Wagerup Alumina Refinery – Production to a Maximum
Capacity of 4.7 Million Tonnes Per Annum and Associated
Bauxite Mining Ministerial Statements 728 and 1069 Request
for Section 46 Review of Conditions

Consultation Addendum

June 2020

Table C: 2018 Base Case Emission Rates

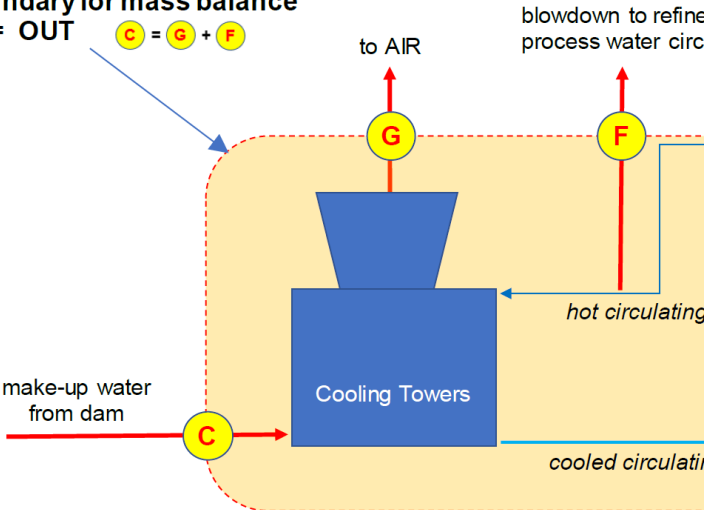
Submitter	Submission and/or issue	Response to Comment						
	<p>increasing conservatism or greater focus on reducing VOC's.</p> <p>AQSB noted some emissions rates that will be used for modelling assessments do not appear to be correct, including CT ammonia emission rates. Noting that the FT-IR method is very sensitive and reliable in its detection of ammonia, this substance has been detected at reasonable concentrations in CT emissions measured by OP-FTIR in 2017 (Table A) as well as in water samples collected from the precipitation CTs (Table B). Emission rates of zero are shown for all CTs (Table C, below). Consequently, the emission data cited in "2018 Wagerup Refinery Emission Inventory Report" do not appear to be representative of Alcoa CT emissions. Ammonia emission rates for other sources are included in the 2018 base case. Ammonia is an odorous compound.</p> <p>Table A: 2017 Ammonia Concentrations at Cooling Tower</p> 	<ul style="list-style-type: none"> Alcoa provided its report on the OP-FTIR work to DWER in May 2019 and was advised that DWER did not consider the technology appropriate for measuring CT emissions. No mention was made that DWER considered OP-FTIR technology appropriate for ammonia while being inappropriate for other substances. Alcoa did not include the ammonia emission rates measured in the initial Emission Inventory using OP-FTIR in the 2018 EI based on the DWER advice. Nevertheless, Alcoa will proceed to include ammonia emission rates in an updated 2018 Emissions Inventory based on the water balance method. The calculation of water balance ammonia emission rates will be provided in the updated 2018 Emission Inventory. Table 1 compares the estimated emission rate from water balance method with the results from the OP-FTIR work and also some earlier stack sampling which was non-detect, but where Alcoa has used ½ detection limit. The estimated emissions from the three methods are all very similar. Alcoa considers that the water balance approach results are the most appropriate and will incorporate them into an updated 2018 Emissions Inventory to be provided to AQSB. <p>Table 1: Comparison of water balance, OP-FTIR and manual stack sampling</p> <table border="1" data-bbox="1167 1070 2056 1423"> <thead> <tr> <th data-bbox="1167 1070 1565 1423">Method</th> <th data-bbox="1565 1070 1794 1423">Average Ammonia Air Emission Concentration</th> <th data-bbox="1794 1070 2056 1423">Peak Ammonia Air Emission Concentration</th> </tr> </thead> <tbody> <tr> <td></td> <td data-bbox="1565 1299 1794 1423">Wet mg/m³</td> <td data-bbox="1794 1299 2056 1423">Wet mg/m³</td> </tr> </tbody> </table>	Method	Average Ammonia Air Emission Concentration	Peak Ammonia Air Emission Concentration		Wet mg/m ³	Wet mg/m ³
Method	Average Ammonia Air Emission Concentration	Peak Ammonia Air Emission Concentration						
	Wet mg/m ³	Wet mg/m ³
